**Subject:** Service Bulletin 159-042-00, Rev. 0  
Load rating increase for TALON 3K Remote Cargo Hook series

**Applicable Part Numbers:** 528-018-02, 528-018-03, 528-018-05, 528-018-06

## SERVICE BULLETIN

Document: 159-042-00

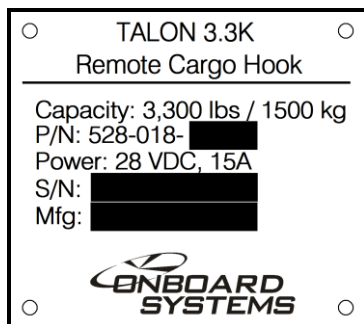
**Description:** Onboard Systems has increased the rated load of the TALON 3K Remote Cargo Hook series, 528-018-02, 528-018-03, 528-018-05, 528-018-06 from 3,000 lbs to 3,300 lbs / 1500 kg through a re-qualification effort. No new parts or modification are required for the increase in load rating.

- 1) **Verify configuration.** Check the configuration of the cargo hook installed by identifying the part number marking on the data plate. The part number should appear in the Applicable Part Numbers list above.
- 2) **Remove and replace Serial Plate.** Remove the existing serial plate by removing 4 drive screws. Side cutters and a flat blade screwdriver will help to lift the heads of the screws and fully remove them. As the existing serial plate and drive screws will be discarded, they can be damaged upon removal.  
Stamp or engrave the complete part number, serial number and manufactured date fields, transcribing the information from the removed serial plate. Install the new serial plate using 4 drive screws (P/N 510-940-00) with hammer and punch.

**Required Materials:** Obtain Serial Plate Kit P/N 200-444-00 prior to beginning the upgrade. This kit includes the component parts necessary for replacement of the serial plate.
